**SAN ANTONIO WATER SYSTEM
W6: Western Watershed Sewer Relief Line – Project I
SAWS Job No. 12-2516
Solicitation No. B-12-039-DD**

**ADDENDUM NO. 1
September 19, 2012**

SAWS PROJECT #12-2516
 FILE NAME:
 180031_TREE_PRESERVATION PHASE 1
 SHEET No
TP-4

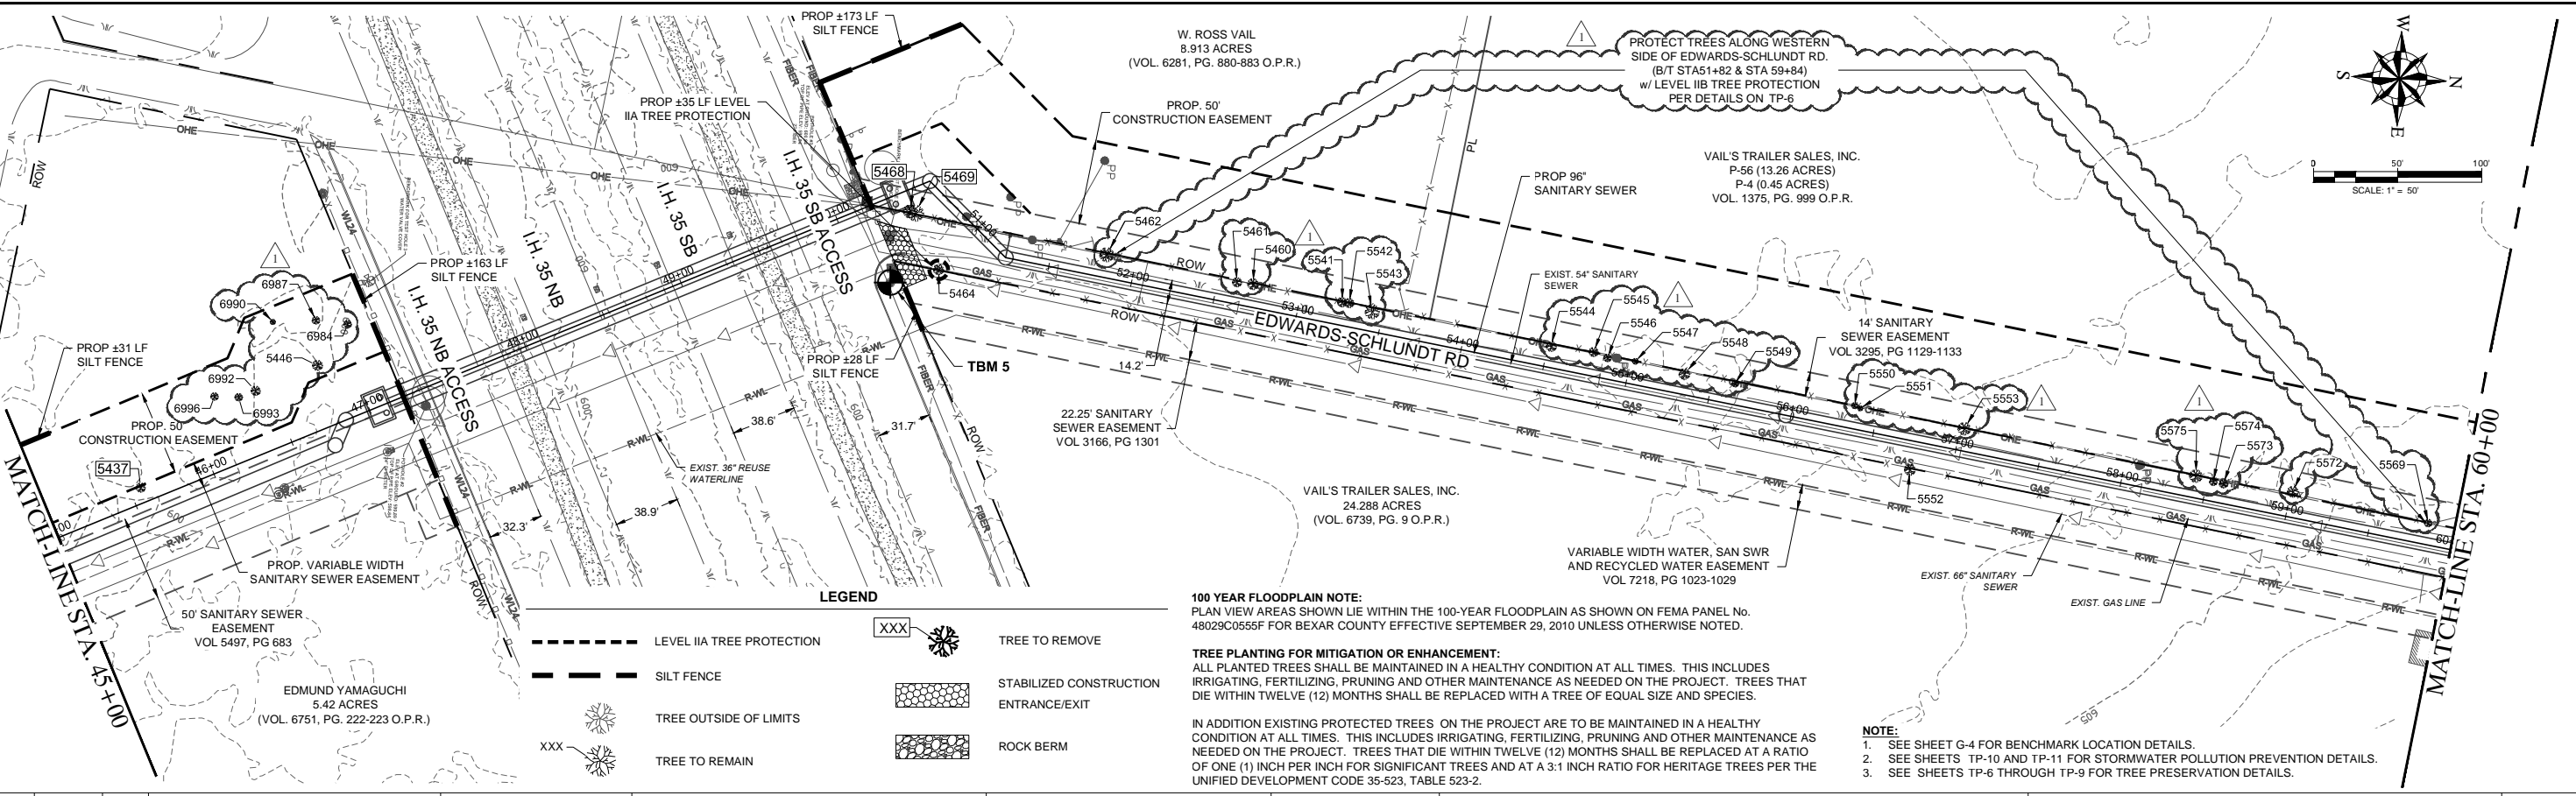
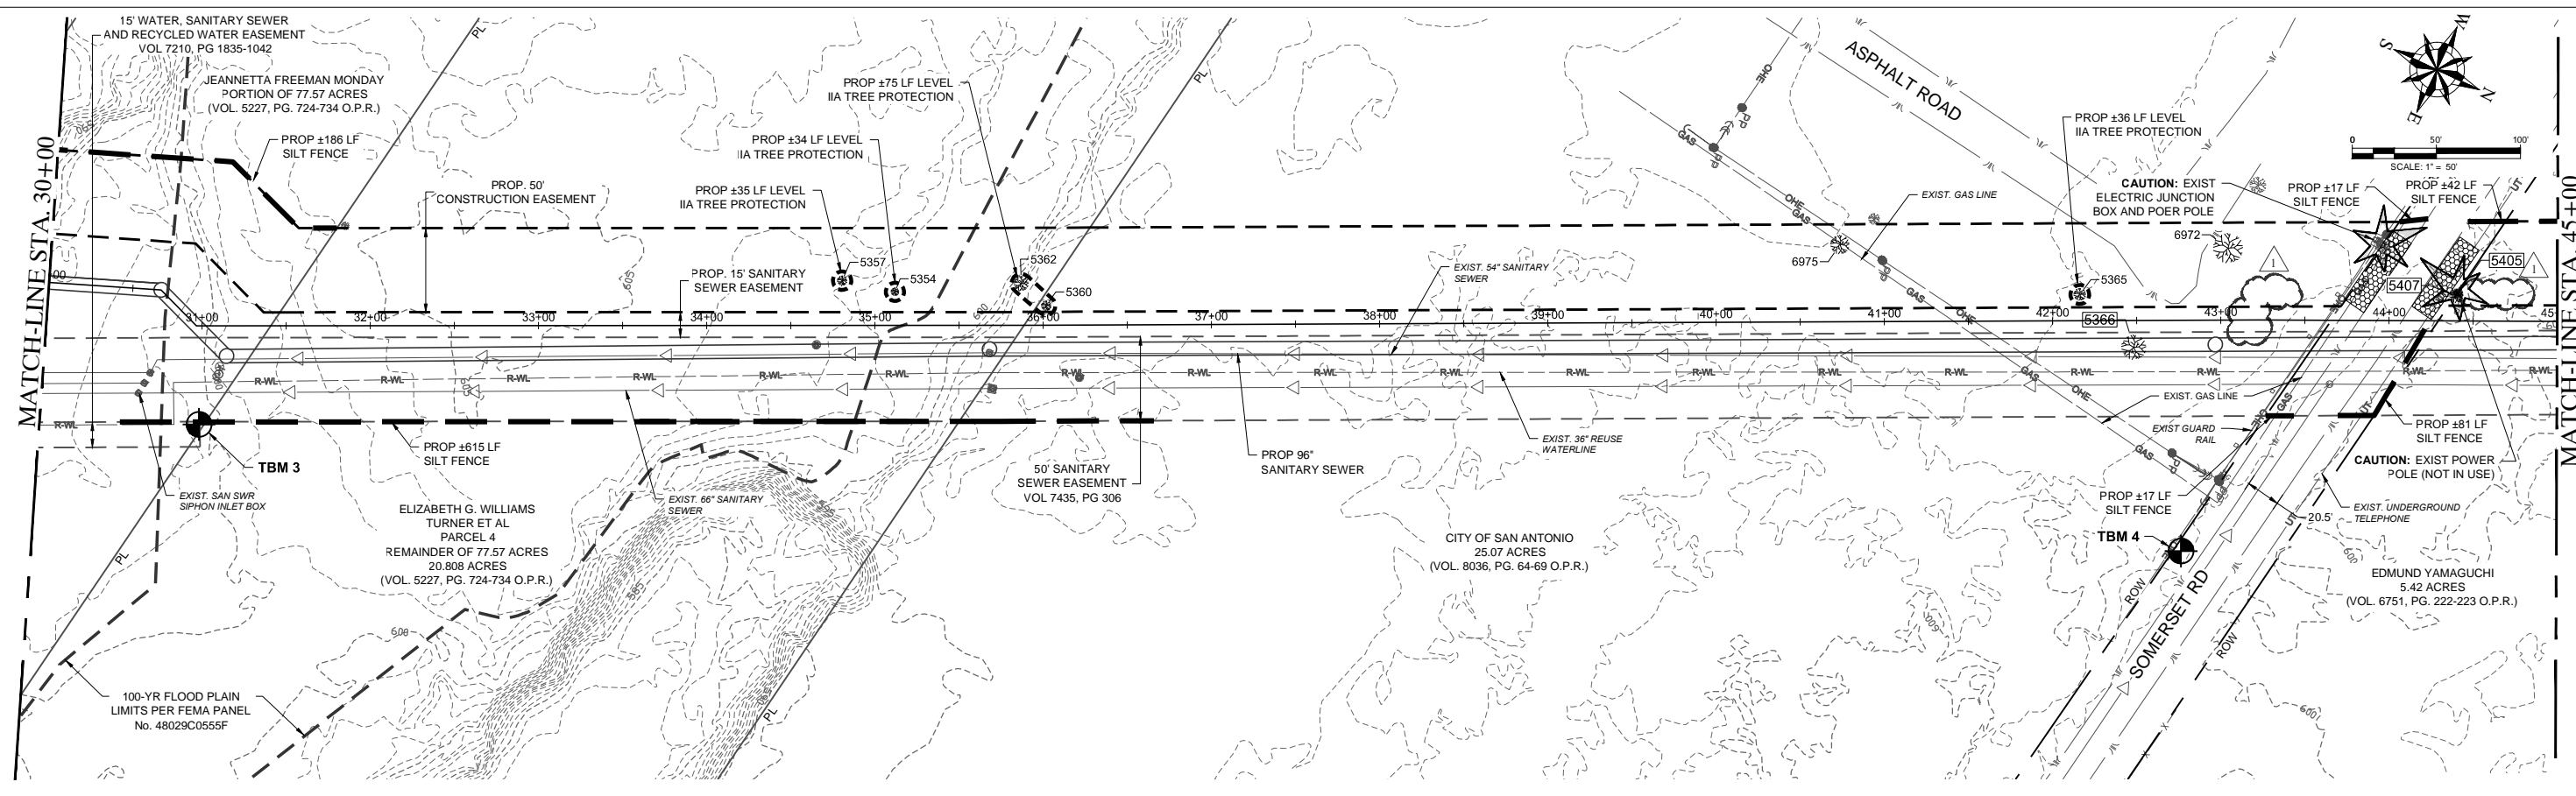
17. **CONSTRUCTION PLANS | SHEET TP-4:** Remove in its entirety and replace with the revised “Sheet TP-4 – Stormwater Pollution Prevention & Tree Preservation Plan: STA 30+00 to 60+00” will be deleted in its entirety and replaced. Revision clouds which appear but have no contents represent trees that have been deleted from the plan per tree inspector comments. The cloud is shown simply to indicate the location of the old tree symbol.
